UNITED STATES
DEPARTMENT OF THE INTERIOR
BUREAU OF LAND MANAGEMENT

SUNDRY NOTICES AND REPORTS ON WELLS
Do not use this form for proposals to drill or to re-enter an abandoned well. Use form 3160-3 (APD) for such proposals.

1. Type of Well <input checked="" type="checkbox"/> Oil Well <input type="checkbox"/> Gas Well <input type="checkbox"/> Other	8. Well Name and No. BALLARD DE FEDERAL 5
2. Name of Operator MARATHON OIL PERMIAN LLC Contact: MELISSA SZUDERA E-Mail: mszudera@marathonoil.com	9. API Well No. 30-025-02445
3a. Address 5555 SAN FELIPE ST HOUSTON, TX 77056	10. Field and Pool or Exploratory Area LYNCH
4. Location of Well (Footage, Sec., T., R., M., or Survey Description) Sec 22 T20S R34E Mer NMP SWSW 330FSL 990FWL	11. County or Parish, State LEA COUNTY, NM

**Permanent Abandonment of Federal Wells
Conditions of Approval**

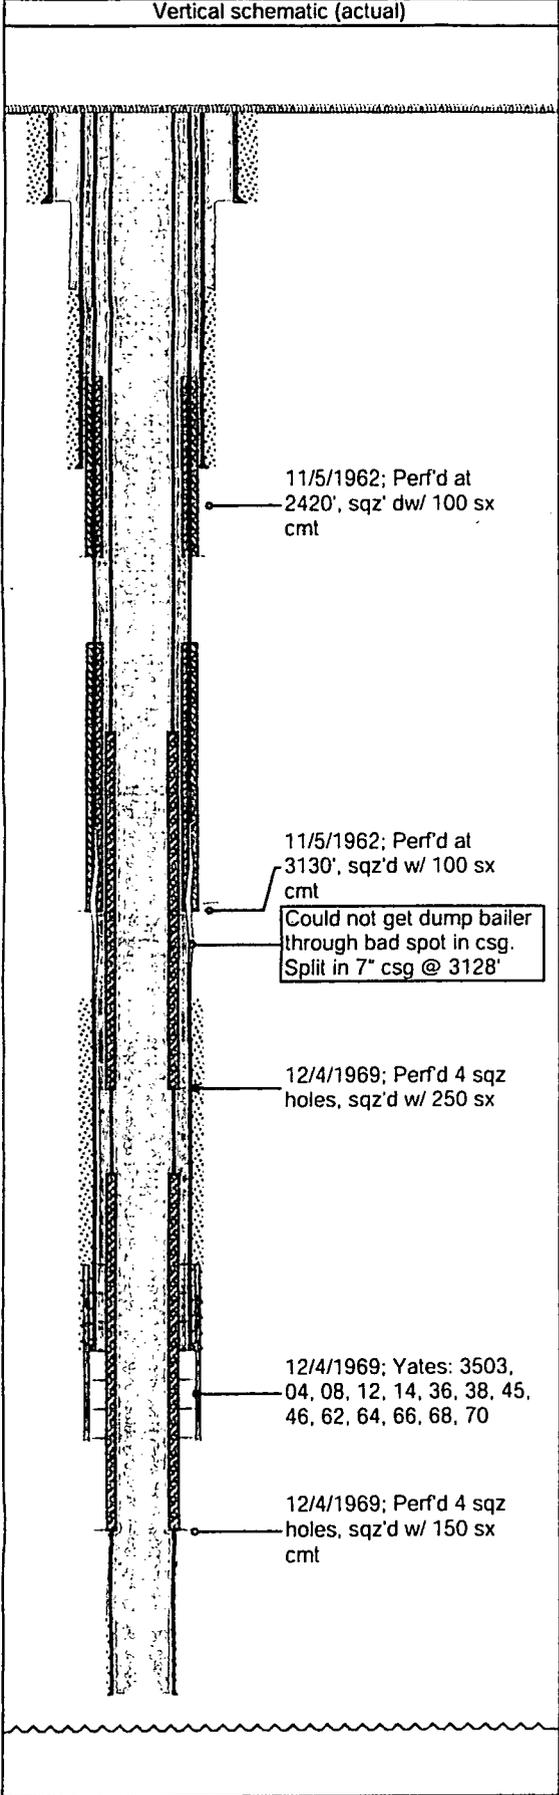
- 1) 4 1/2 CIBP @ 3,400' w/30sx
- 2) 95sx P&S 2,400' - 2,000' tag.
- 3) 40sx P&S 1,618' - 1,518' tag.
- 4) P&S 100' - Surf w/70sx. Verify. Install DHM.

P&A mud between all plugs.
Closed loop.
All fluids to licensed facility.

- 1. CIBP @ 3483' spot Class C from 3483-3349. WOC & TAC
- 2. Perf @ 3057'. Squeeze from 3057-2000ft WOC & TAC
